# KUBÍČEK

## SERVICE BULLETIN No. 54

- 1. WITH REFERENCE TO:** Cameron Balloons Ltd. fuel cylinders CB2990 (Alugas)
- 2. REASON:** Cracks in the weld of aluminium fuel cylinders CB2990 (Alugas) - fuel leak.

# Alert Service Bulletin No 33

Figure 1 - Section indicating Valve Plate

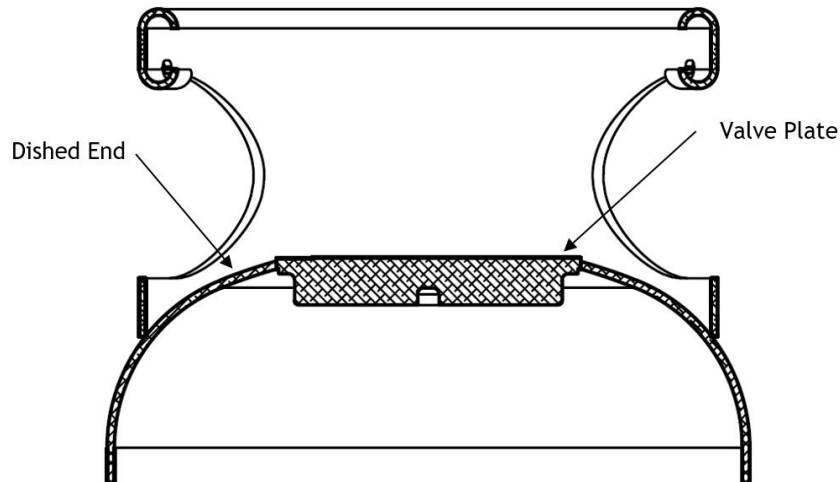
Five CB2990 (Alugas) cylinders have developed cracks in the weld between the cylinder valve plate and the upper dished end. These cracks allow the release of propane from the cylinder. Failures have been observed during periodic inspection (hydraulic pressure test), and leak test. All the in-service failures seen to date have been from the batch of cylinders with serial numbers starting OC.

Within 24 hours of receipt of this bulletin affected cylinders must be checked for leaking around the interface between the cylinder valve plate and the upper dished end using leak detector fluid. Any cylinders found to be leaking must be emptied of fuel immediately. A pilot may carry out this inspection. A satisfactory leak check **does not** release the cylinder to service.

Within 7 days of receipt of this bulletin affected cylinders must be emptied of fuel.
